**Re: Modifications to Minister's approval for the Western Sydney Recycled Water Initiative - Replacement Flows Project**

Figure 1 - Replacement Flows Project, Potential Modification  
Cumberland Plain Woodland, near Penrith STP

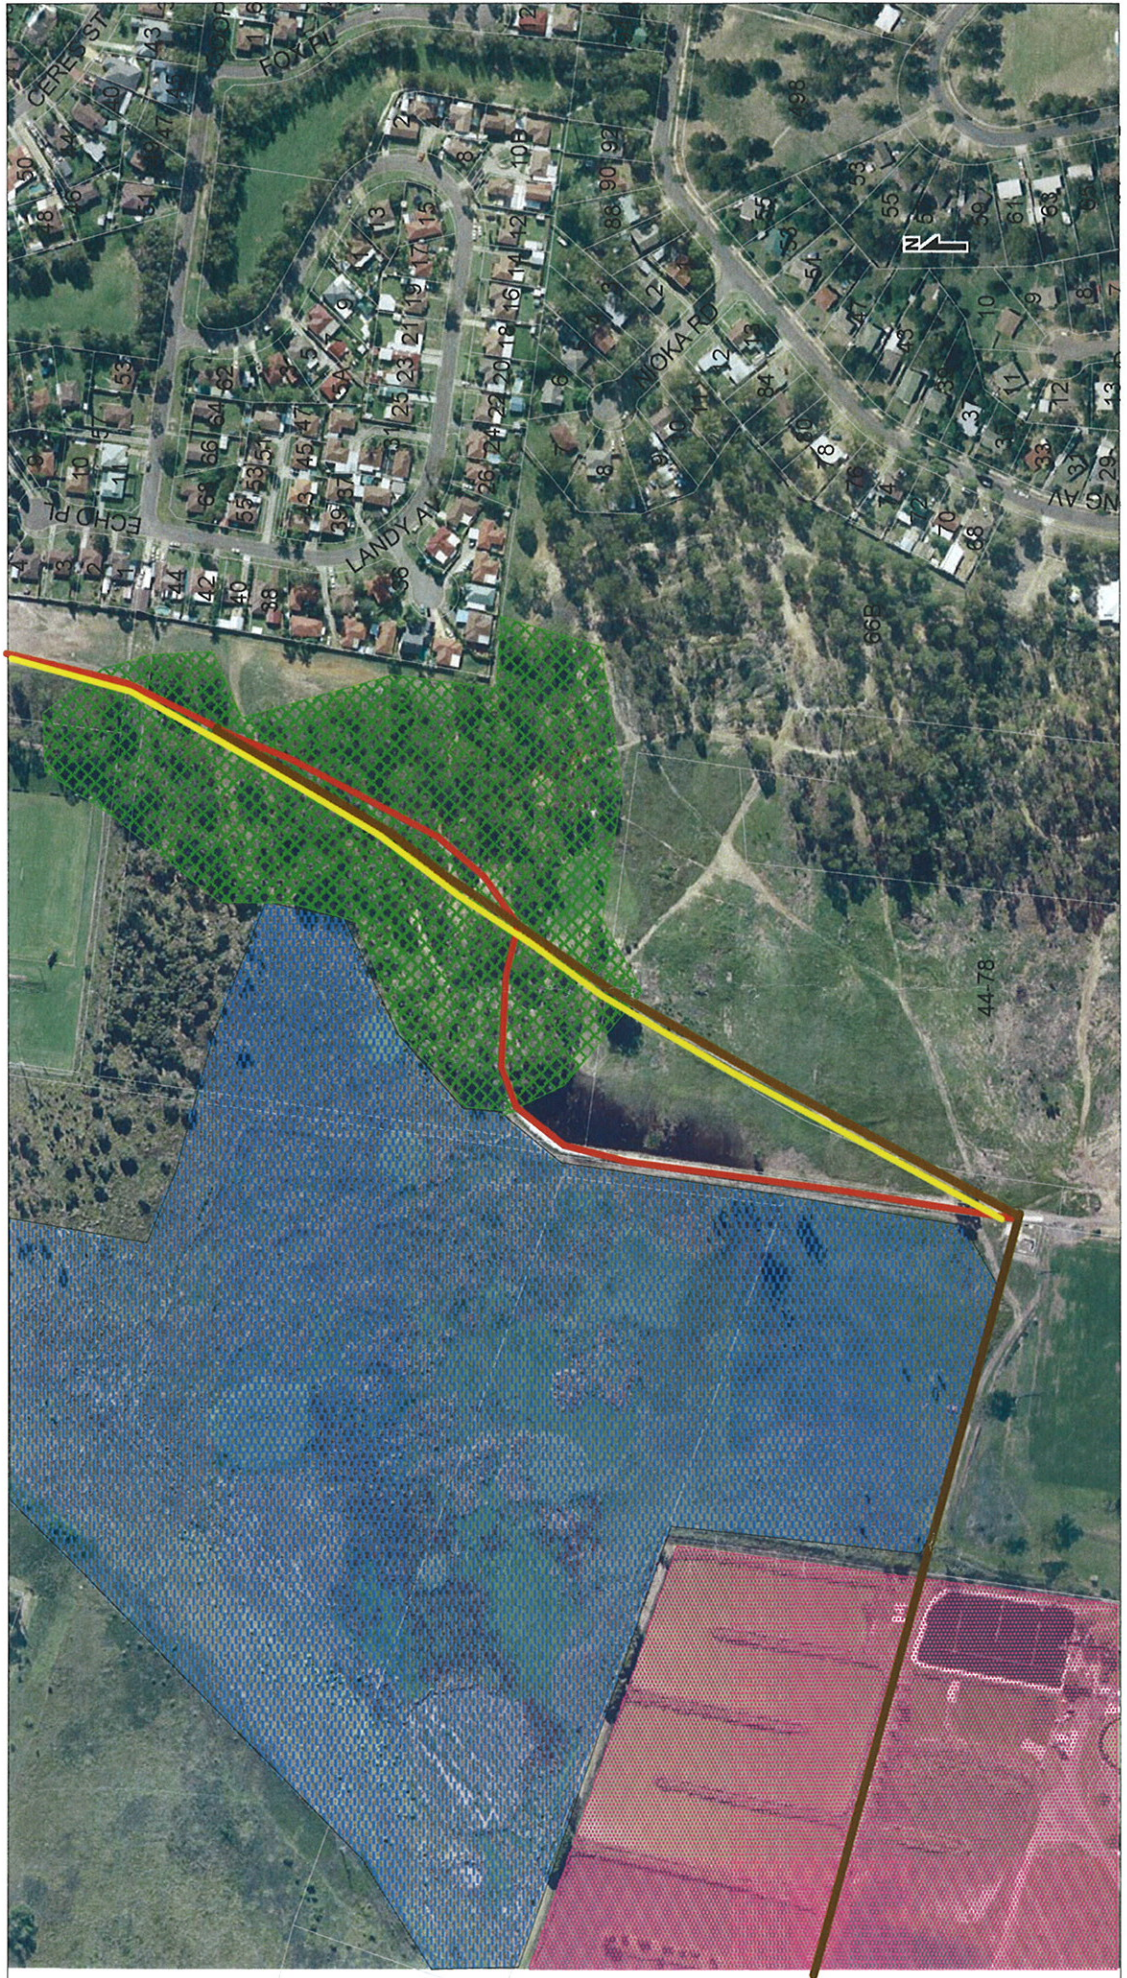
As a result of reviewing the detailed design of the pipeline in this area, it has become apparent that the original alignment through the Cumberland Plain Woodland is unlikely to be feasible, without the need to remove some trees adjacent to the sealed pathway. A re-alignment is now proposed which could utilise an existing disturbed sewer corridor through the Cumberland Plain Woodland. This re-alignment would be shorter and straighter. As such, construction techniques would cause less impact because a narrower trench would be possible and no additional excavation would be needed for thrust blocks and bends.

An arborist has advised that it is likely that no large trees would need to be removed along the proposed re-alignment, although some hand excavation or underboring may be required around one particular tree. The original alignment was adjacent to a wetland area and some groundwater issues would have needed to be managed during design and construction. The proposed re-alignment is located approximately 150m to the north of the wetland area and would avoid any groundwater issues and potential indirect impacts to the wetland area.

Condition of Approval 2.11 requires that the Project avoid direct impact to Cumberland Plain Woodland. Although tree removal may not be required, the disturbed sewer corridor may contain Cumberland Plain Woodland regrowth. SWC is therefore assessing this re-alignment for potential flora and fauna impacts. This assessment will also advise on whether a re-referral to the Department of the Environment, Water, Heritage and the Arts is also required.

SWC may therefore need to request a modification to CoA 2.11 to allow minor direct impacts to the Cumberland Plain Woodland in this area.
